## Addendum #3

Attn: Estimator	Date: June 5, 2020
From: Lisa Donahue, Project Administrator	Pages: 10 (including cover page)
Re: Harrison Community Schools 2017 Bond Projects – Series 2	Project: Larson Elementary Addition and Renovations
CC:	Proj. #: A19912

No:	3	Project Number:	15-555
Project:	Harrison Community Schools (2018 School Bond Projects – Series 2)	Date:	6/5/20

**GYMNASIUM/MULTI-PURPOSE SPEAKER MOUNTING DETAIL**

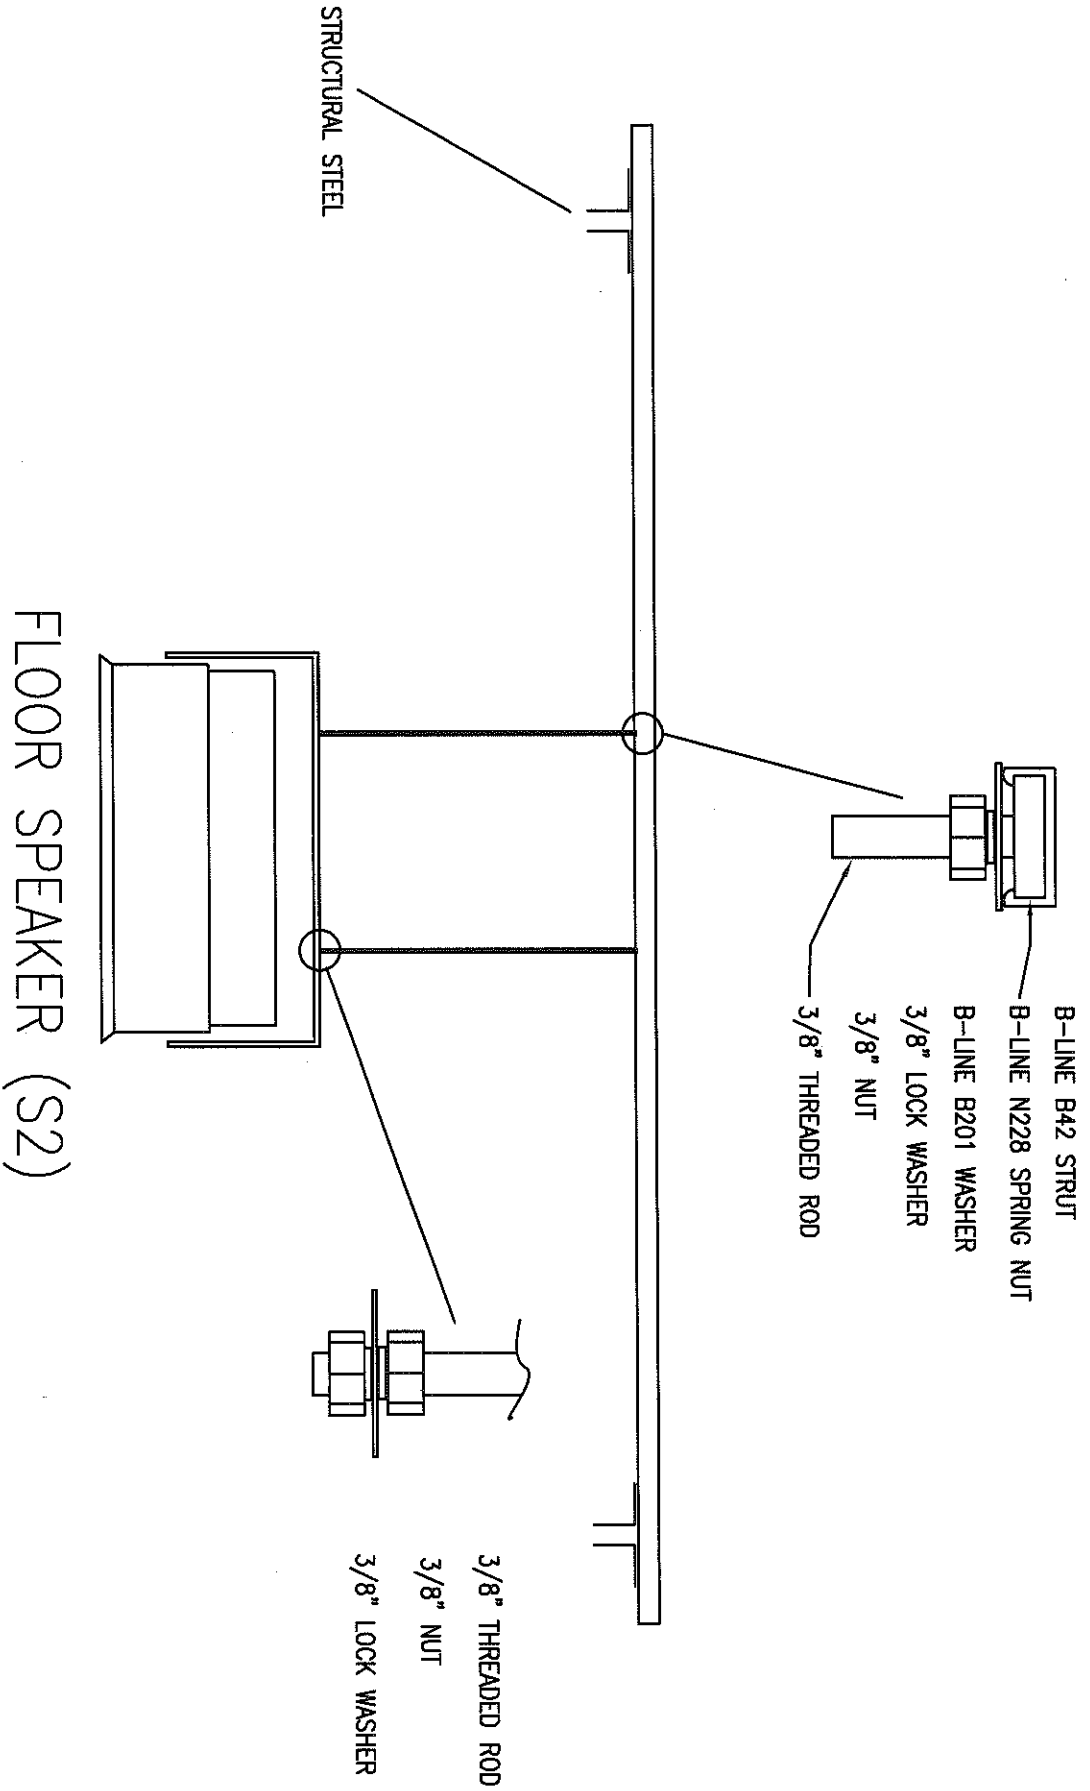
- d. Keynote #26 – See attached speaker mounting detail.
  - e. Keynote #3 – Mounting plate is to be provided and installed by Electrical Contractor. Owner is providing projector and mounting projector to mounting plate.
